Agenda Item No: 8
Report To: Joint Transportation Board
Date: Tuesday 19th February 2013
Report Title: Willesborough Lees Highway Safety Scheme
Report Author: Ray Wilkinson

Report Title: Willesborough Lees Highway Safety Scheme

PROJECT WILLESBOROUGH LEES HIGHWAY SAFETY SCHEME	
DRG.TITLE EXTENT OF PROPOSED RESTRICTIONS	
SCALE(S) 1/800	PAPER SIZE A1
DRAWN R.JW	AUTOCAD FILE DATE JAN 2013
DRG.No. WILLESBOROUGH 09	REV. -

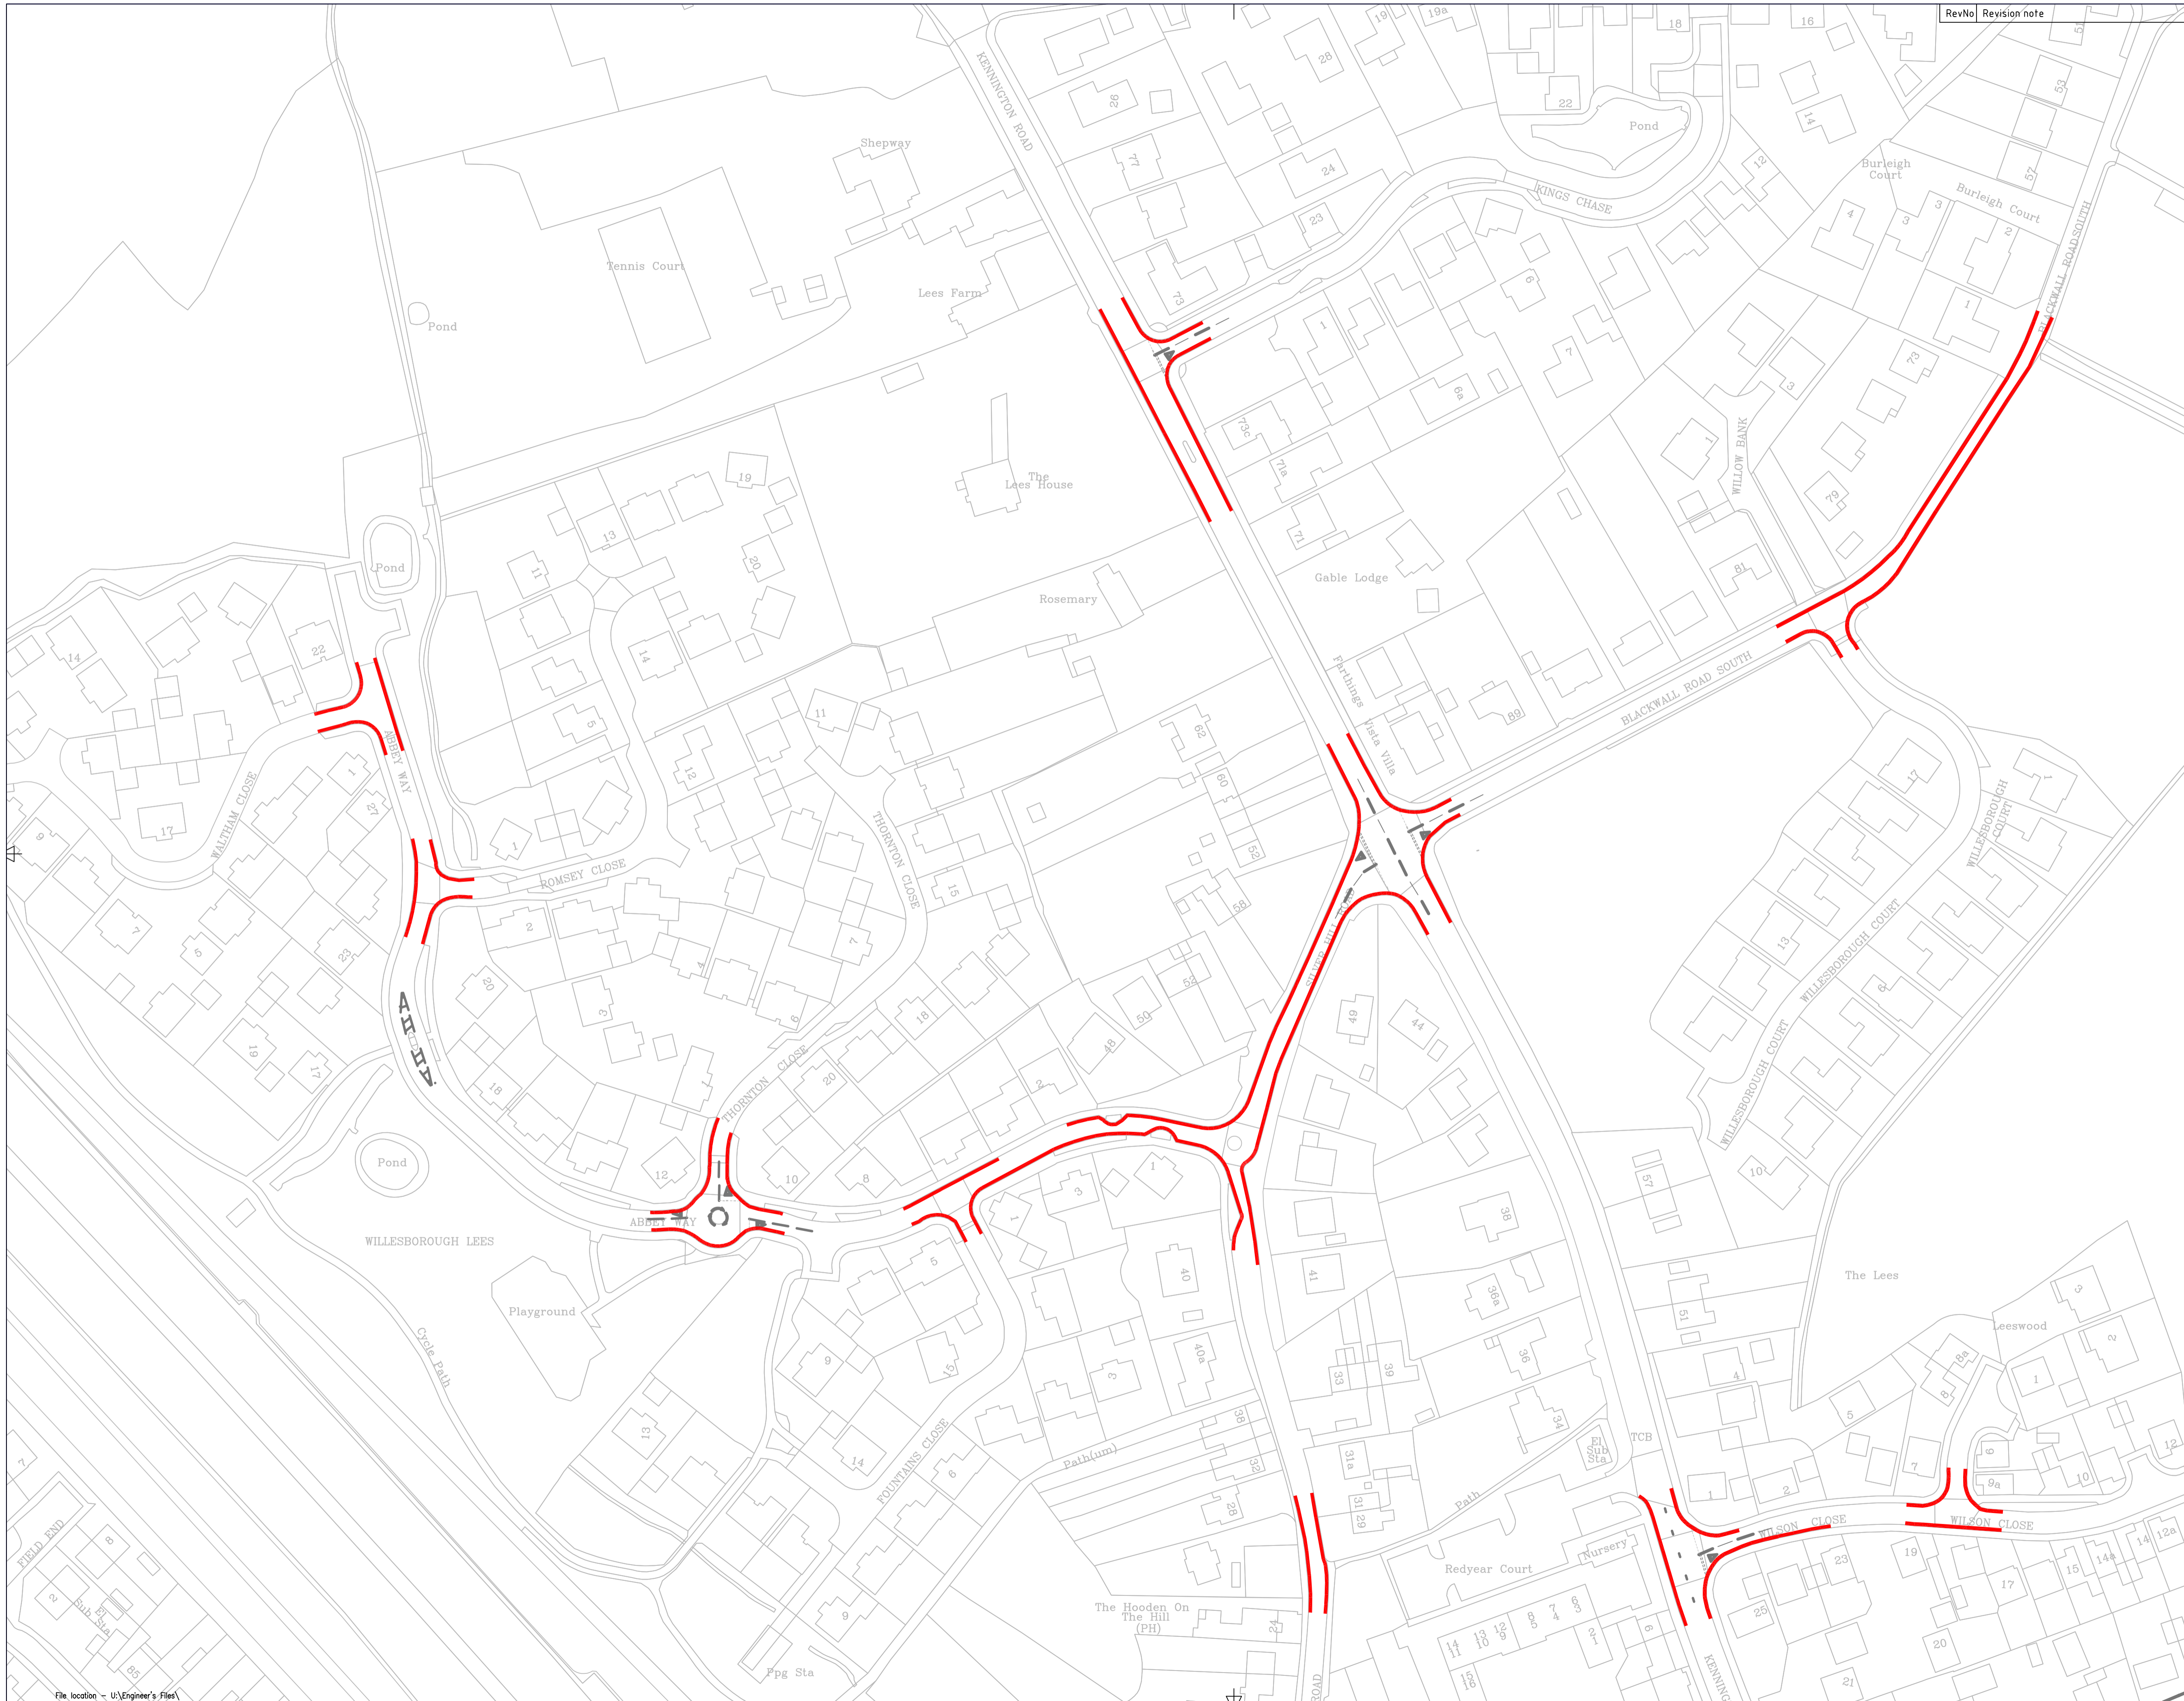
33. 10 of the representations requested that the proposed 'no waiting at any time' restrictions were extended. These requests related to various different locations including Silver Hill Road, Blackwall Road, Wilson Close, Cornes Close and Waltham Close. The requests were made in response to concerns over a variety of issues including emergency / refuse vehicle access, footway parking, protection of sight lines and access to private driveways.

Am26/03	<p>I am the owner of ** Silver Hill Road. I am opposed to the plans for the introduction of yellow lines to majority of the proposed areas due to the current problems with parking already. It is often difficult to park on Silver Hill Road during the day as more and more people use the road as parking for their offices and jobs, adding yellow lines will make finding a parking space even more strained.</p> <p>A suggested solution which would benefit the residents would be to introduce resident parking permits/passes.</p>
Am26/04	<p>I Live at ** Wilson Close, which is the first non-tarmac turning off the road. With parking on the opposite side of our entrance it is difficult to exit our driveway at any time. The difficulty is significantly worsened when there is snow and ice as we have an uphill start onto the main part of the road and having to make a sharp turn can cause sliding. It would be significantly safer for me, and my neighbours if the double yellow lines on the south side of Wilson Close are extended to the start boundary line of no. 19.</p>

34. All requests were examined individually, however as discussed earlier in this report the proposed safety scheme aims to introduce a minimum of restrictions to address dangerous and obstructive parking. It is the view of Officers that these additional restrictions cannot be justified at this time. Should the scheme be approved the post-implementation review will of course act as a check to ensure that should any further issues emerge that they be addressed as necessary.

PROJECT		WILLESBOROUGH LEES HIGHWAY SAFETY SCHEME	
DRG.TITLE		EXTENT OF PROPOSED RESTRICTIONS	
SCALE(S)	1/800	PAPER SIZE	A1
DRAWN	RJW	AUTOCAD FILE	DATE
DRG.No	WILLESBOROUGH 10	REV.	JAN 2013

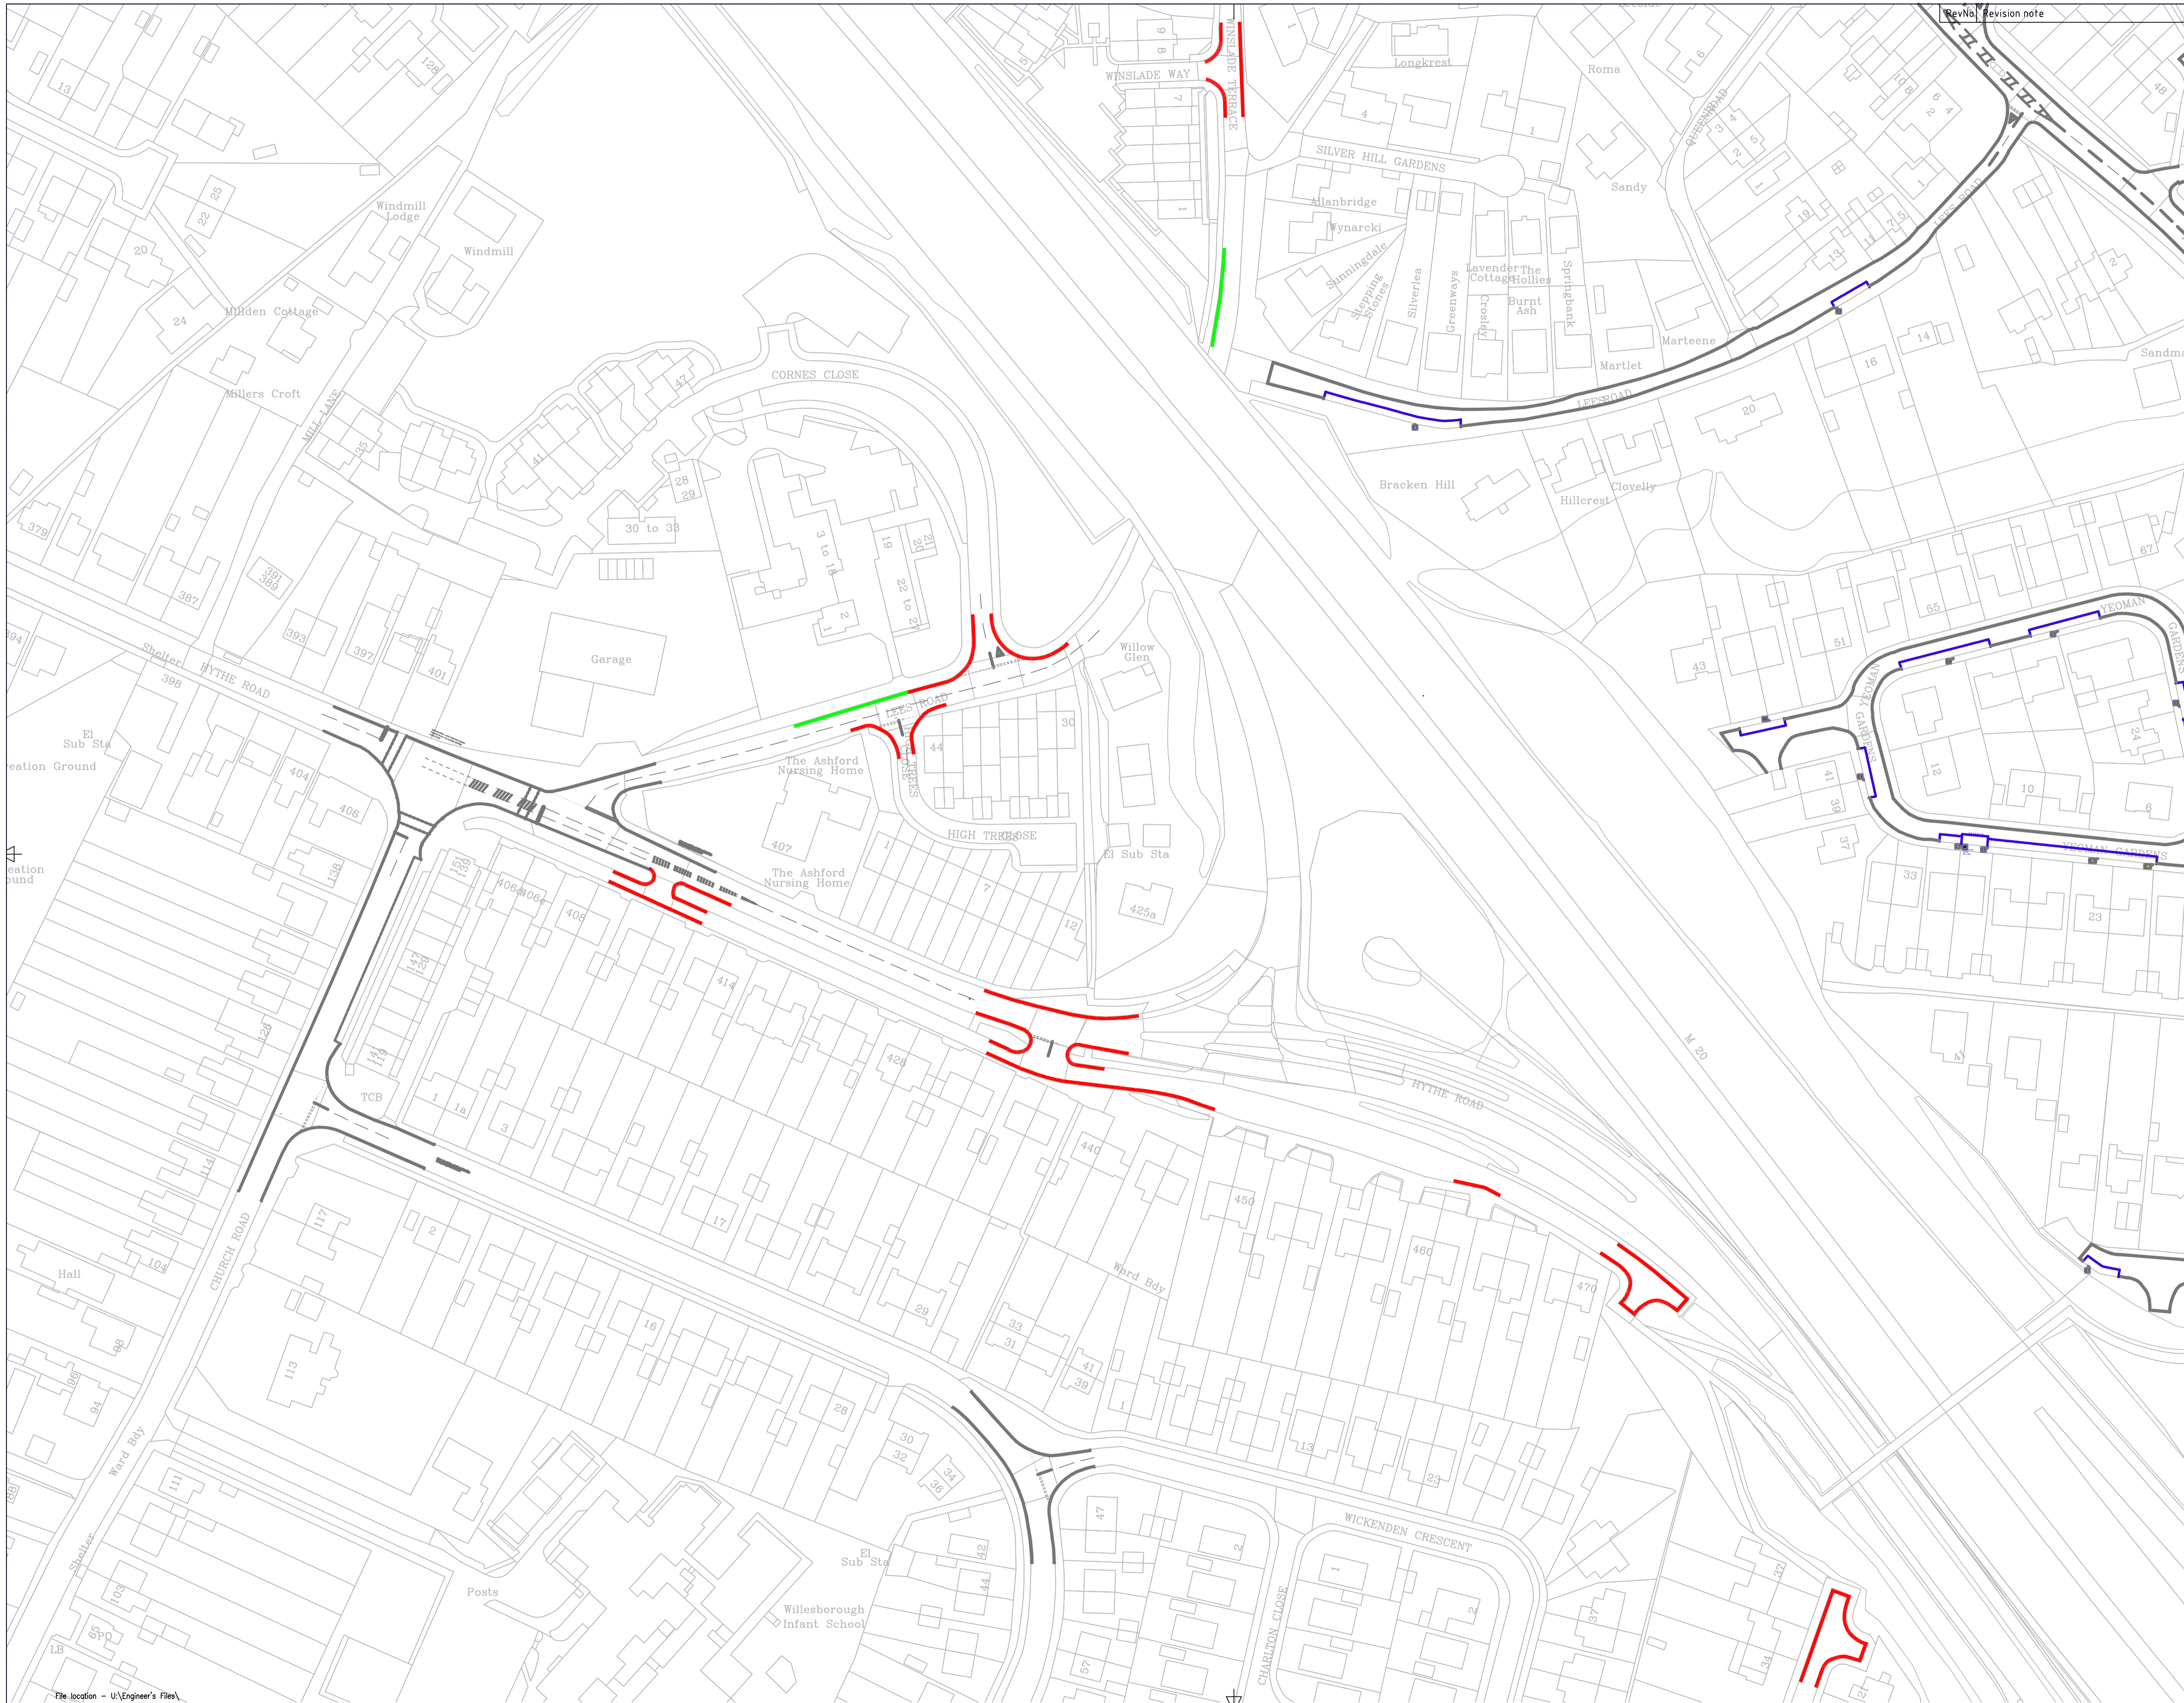
Am26/05	<p>Ref your proposals</p> <p>The parking problem in Blackwall Road/ Willesborough Court only exists 7am to 4.30 pm Mon to Friday and partially on Saturdays the proposal to install double yellow lines will greatly inconvenience house holders. Can you please consider single yellow lines with time restricted parking of say 2/3 hrs with double yellow lines at the junctions. This will provide greater flexibility</p>
Am26/06	<p>I would welcome some form of parking restrictions in Willesborough Lees.</p> <p>Most mornings I walk up Silverhill Road and many times I have to walk in the road owing to cars parked on the footpath. Also my husband uses an electric buggy which means it is nearly impossible to use it in this area. I have noticed that recently there are several cars parked on the pavement under the motorway bridge. On the rare occasion that the street cleaner visits the vehicle cannot get anywhere near the edge of the road consequently there is a build up of rubbish and equally importantly leaves blocking the drains.</p>

<ol style="list-style-type: none"> 1. I am in agreement with the proposed placement of double yellow lines on both sides of the north end of Blackwall Road South, and at the junctions of: a) Kennington Road / Blackwall Road South, and b) Blackwall Road South / Willesborough Court. 2. These proposals will go some way to improving safety; however they will not address the bulk of the problems faced by the residents who live in this area, or those individuals who have to use Blackwall Road South to get to and from their place of residence. 3. The current commuter / unsociable parking in Blackwall Road South, caused predominantly by staff from the William Harvey hospital, creates problems for resident to get into and out of their drives, makes it very difficult and risky to drive up and down the road, and has resulted in a number of confrontational incidents between the drivers of cars travelling in opposite directions on the only lane left open down the entire road. 4. The inclusion of single yellow lines on both sides of the remainder of Blackwall Road South, with parking barred for a one or two hour period at a strategic time of the day should be added to the proposal. This would make it impossible for staff to "commuter" park whilst still making the space available for the short term parking of visitors to both the residents and the hospital. This is a system that works well in similar areas of Canterbury. 5. A similar single yellow line should also be placed on both sides of Willesborough Court to avoid simply pushing the problem elsewhere.
